WORKSHOP AGENDA

Planning Commission

July 15, 2025 @ 5:30 PM

Item #: 3. Site Plan – Smoke Club 13 – New Building of 2,759 Square Feet on 0.42 Acres. Requested by Dean Design Group. Property located at 5234 Murfreesboro Road (Tax Map 15M, Group C, Parcel 6). C-2 (Highway Service) Zoning District. Property owned by Smoke Club 13, LLC. (DEFERRED)

C1.2
EROSION
CONTROL PLAN

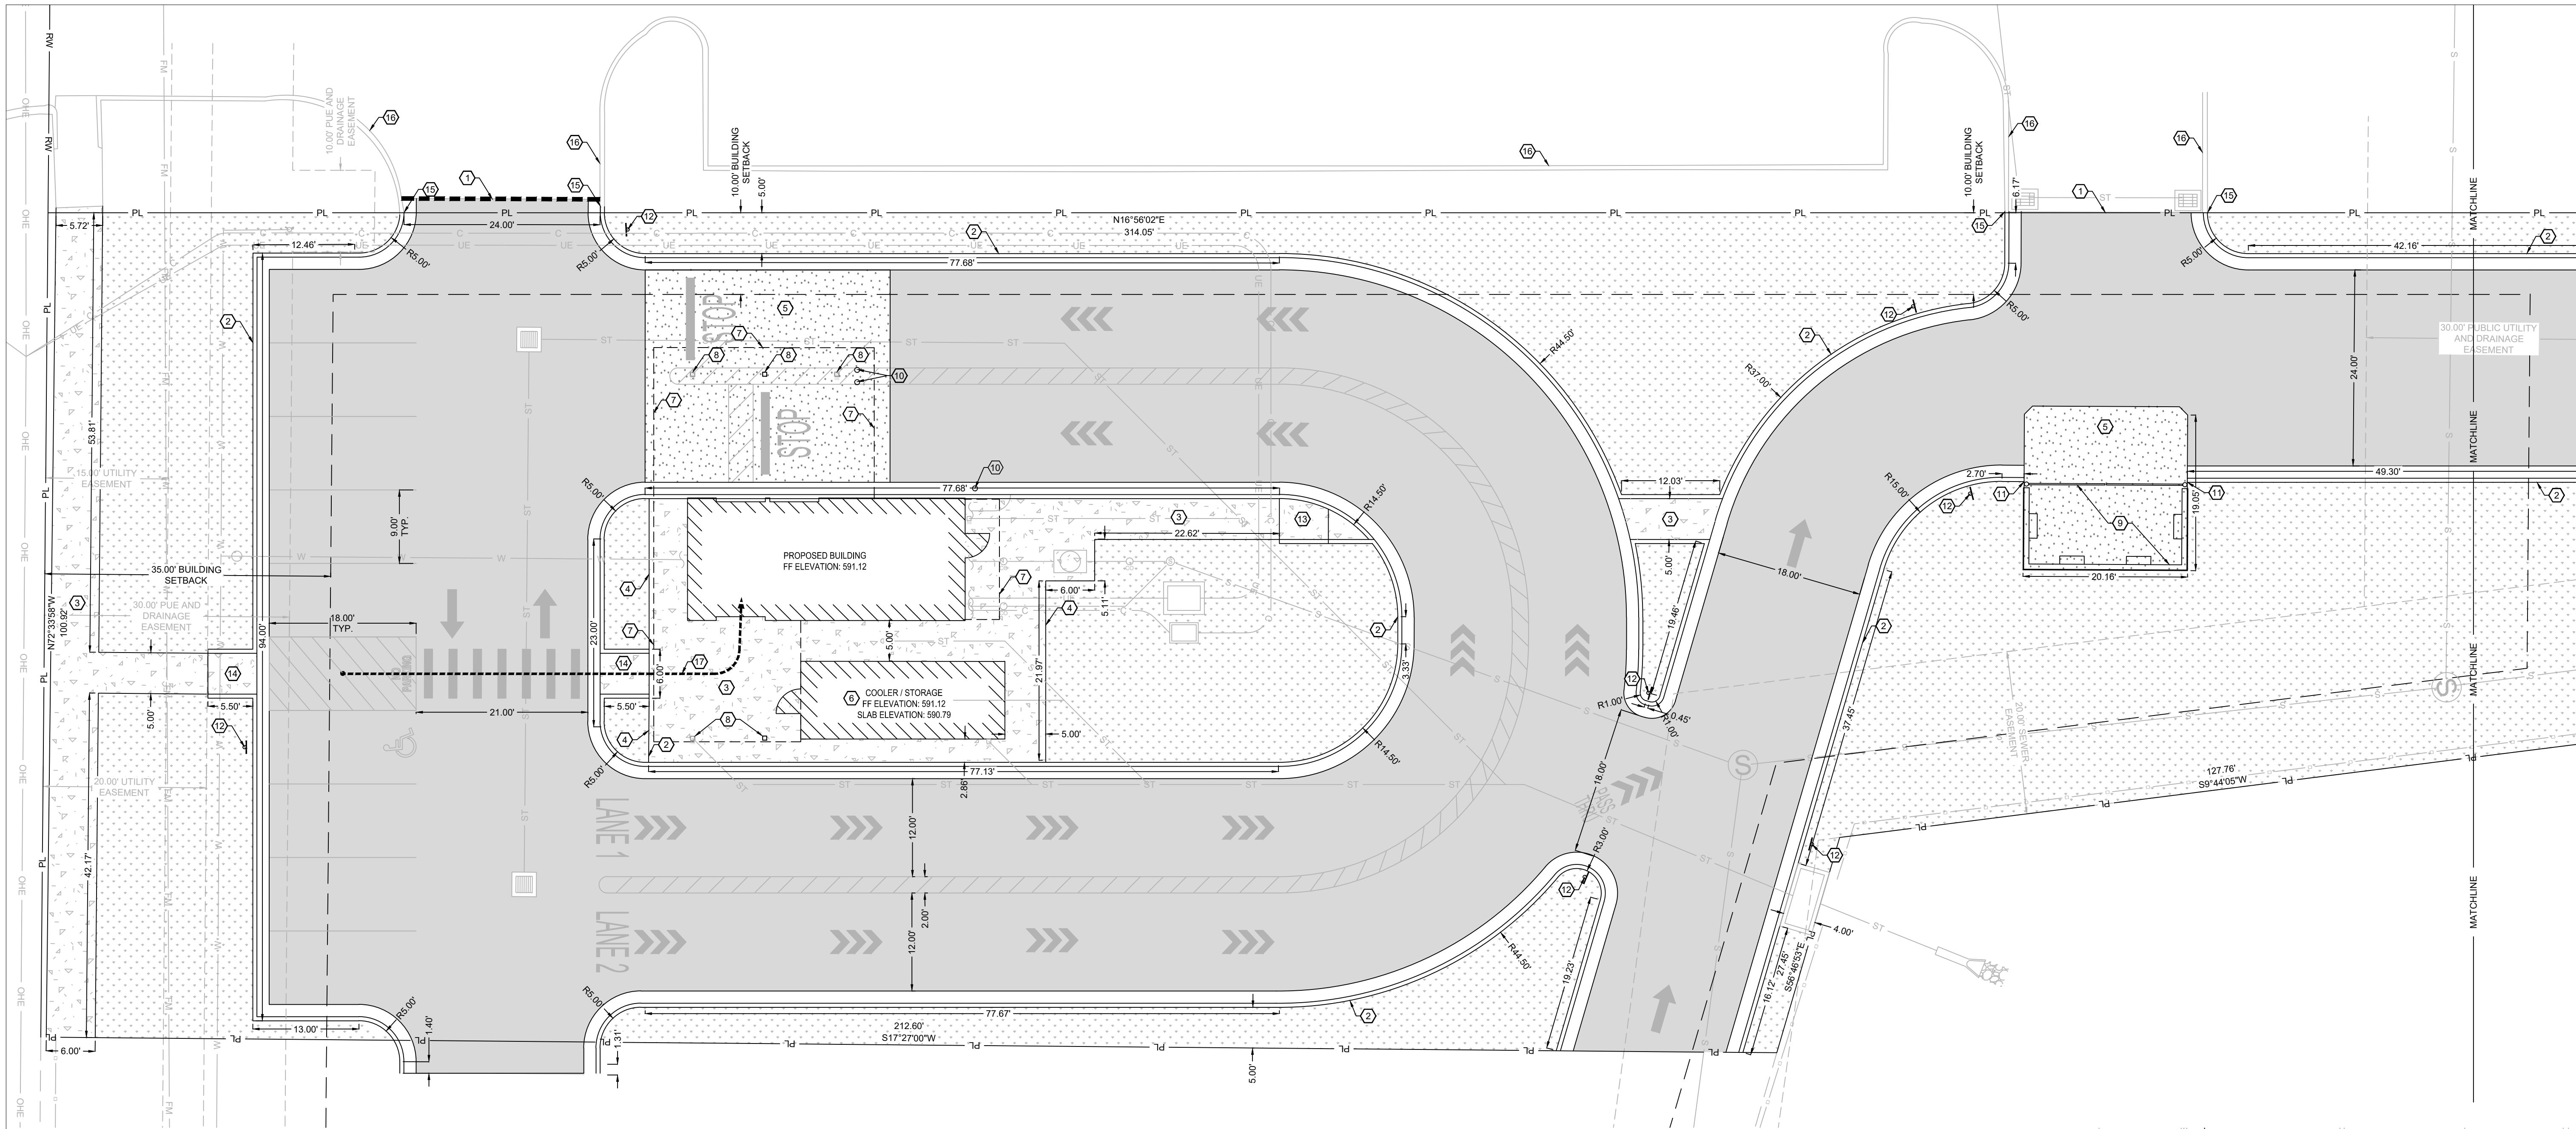
15. (Sheet C2.1) If a monument or other free-standing sign is planned for the site, please note the location on the Site Plan.
16. (Sheet C1.2) A minimum of an initial erosion control plan and a final erosion control plan is required. The final erosion control plan can be included on the final grading plan sheet. Call out means to final stabilize all disturbed areas of the site.

17. (Sheet C1.2) Provide easements or agreements for all work to be occurring off of the site.
18. (Sheet C7.1) Provide silt fence installation detail
19. (Sheet C7.1) Provide 'compost filter sock' installation detail.

C2.1
SITE PLAN

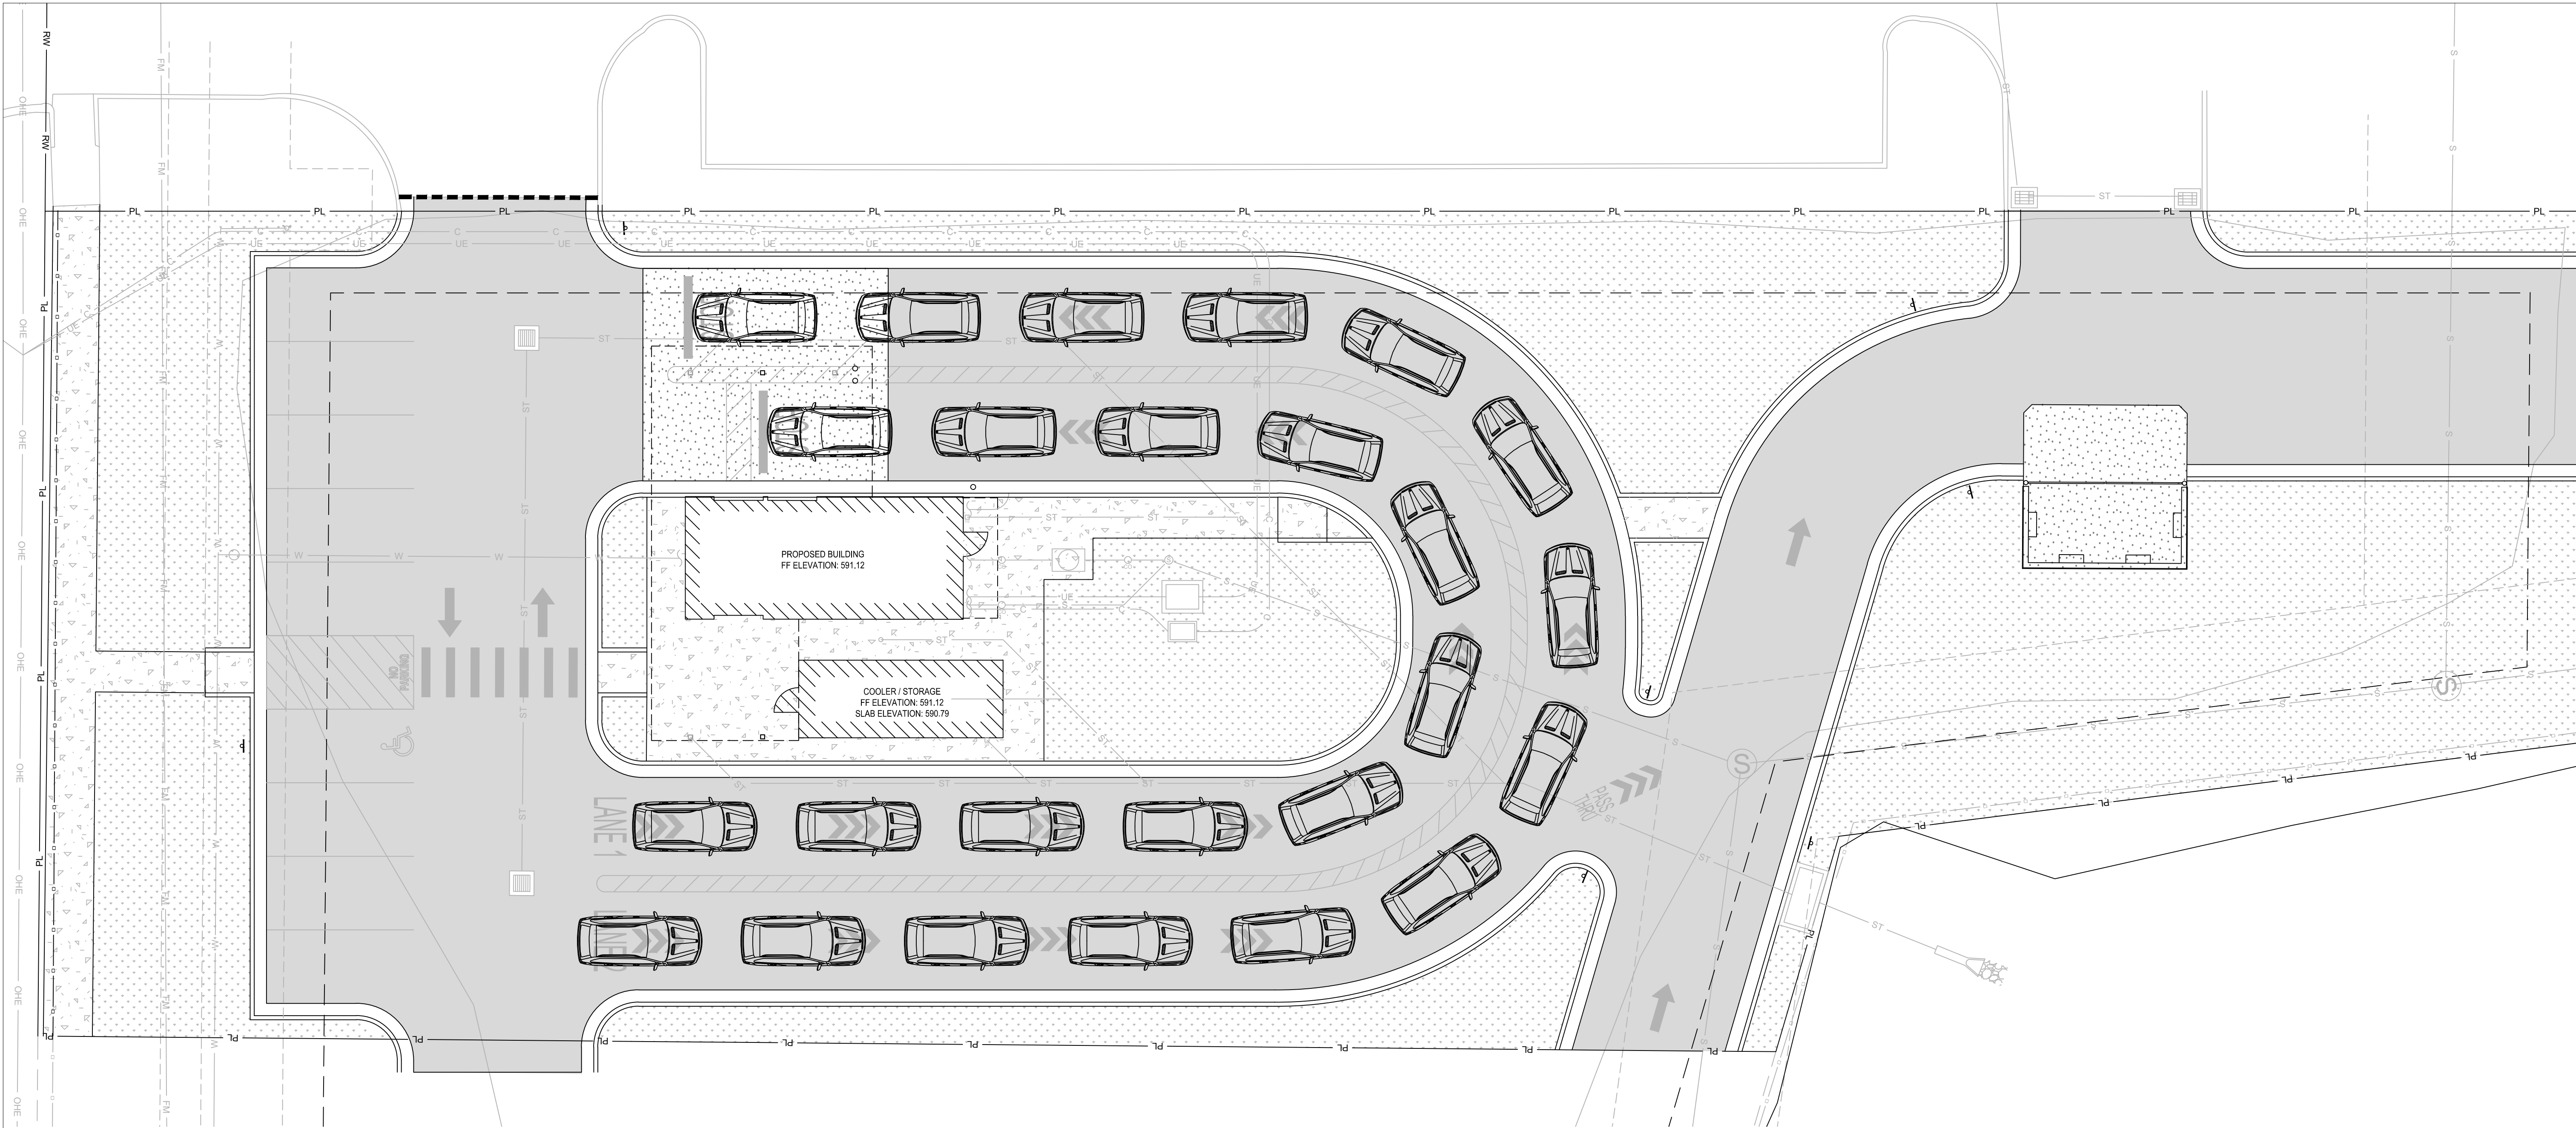
3. (Sheet C0.1) Include required city-standard General Notes (see city website - Engineering Department for download)
4. (Sheet C2.1) Show bearings and distances on property lines

5. (Sheet C2.1) Show dimensions to proposed building off of at least two property lines to precisely locate the building on the lot. Also provide bearing for building wall or locate a second building corner.

6. (Sheet C2.1) Locate cooler storage building relative to main building in both directions. It is only located in one direction on the present submittal.

12. (Sheet C2.1) Dumpster enclosure wall and gate elevations and details must be included with the Site Plan submittal.
13. (Sheet C3.1) The grading plan shows cut and fill occurring on Uptown Lot #8 to the east of this site. Please provide a copy of an agreement from the owner of Lot #8 providing the right to grade in this manner.

14. (Sheet C2.1) Add a note in the match line area in the lower right of the sheet noting that the Joint Access Agreement for the drive to the north of the site is recorded in RB 1874, PG 3850 RORCT.

20. (Sheet C2.1) Please show traffic patterns for this site assuming that it develops before the site to the immediate west. The city has yet to receive a site plan submittal from that site nor any plans showing the access from Murfreesboro Road through that site being constructed.

C3.1
GRADING PLAN

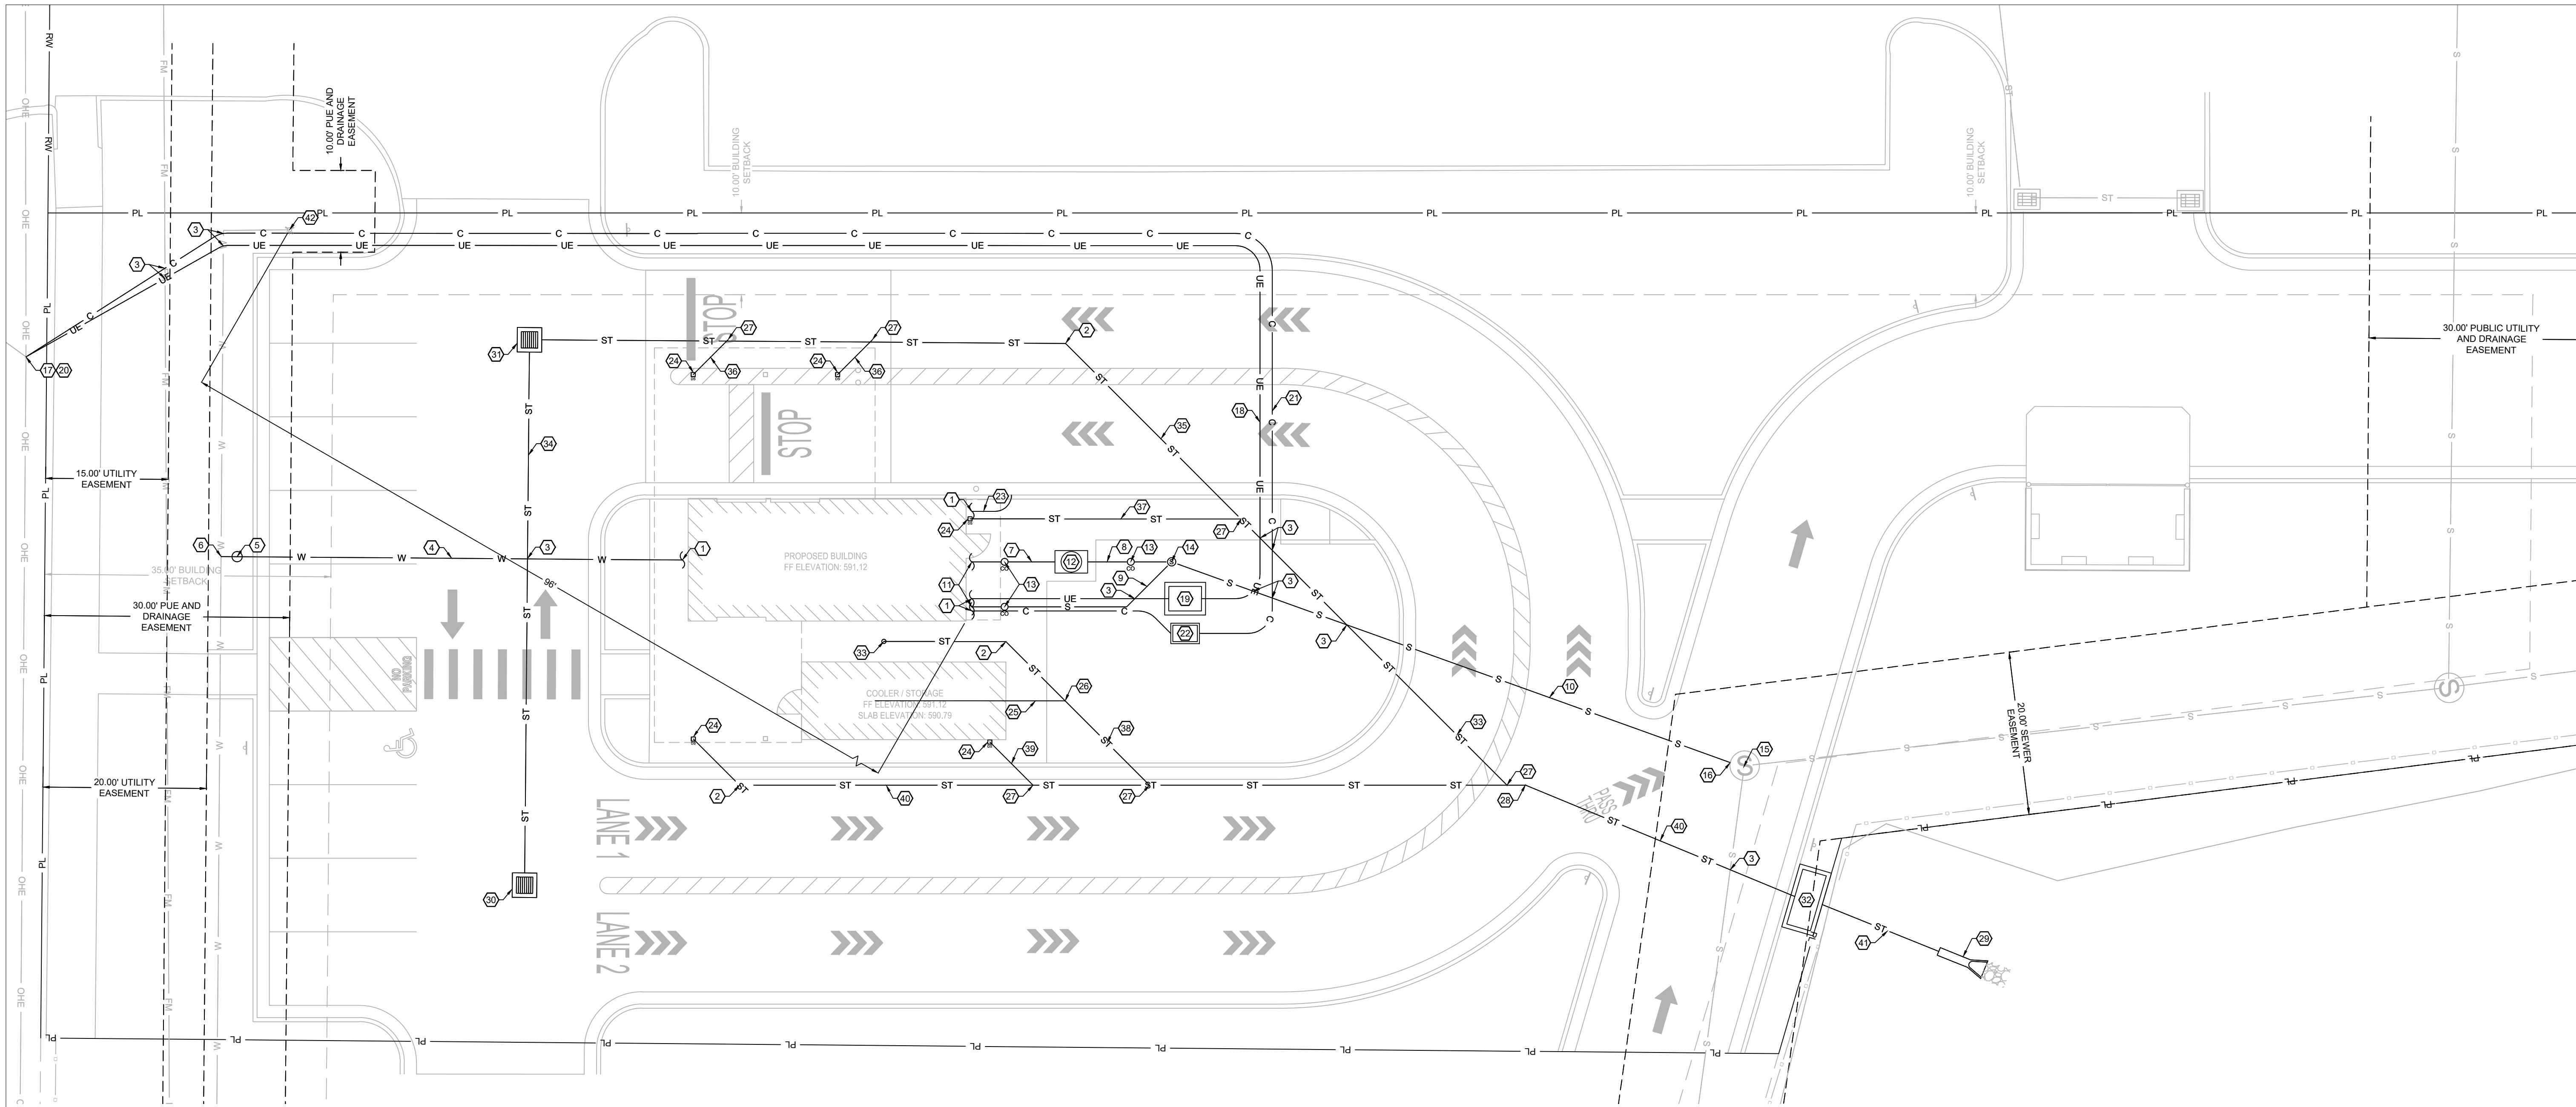
2. (Sheet C3.1) (similar to comment 1 above) The grading plan shows fill being placed onto the Villas at Central Park property. Some form of temporary or permanent easement must be recorded for this fill placement and the associated construction. Staff cannot recommend approval without this easement in place.
